ADDENDUM No. 2

TOWN CREEK RESERVOIR DAM ABUTMENT DRAIN & DOWN DRAIN REPAIRS

DATE: July 29, 2025

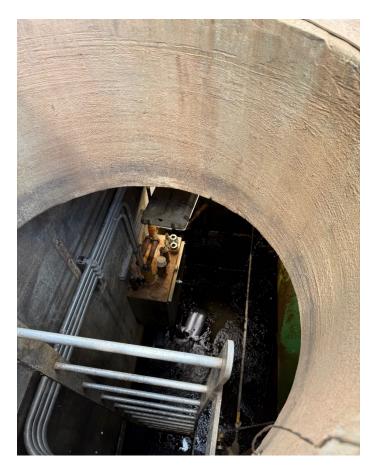
6) QUESTION: There is a manhole near the right abutment drain? What is it and do you know where the line goes?

RESPONSE: It is assumed that the 48" reservoir drain runs to this manhole and continues south towards the Ocmulgee river pump station wells. Contractor to field verify inverts and report any conflicts to the Owner and Engineer prior to the start of construction.
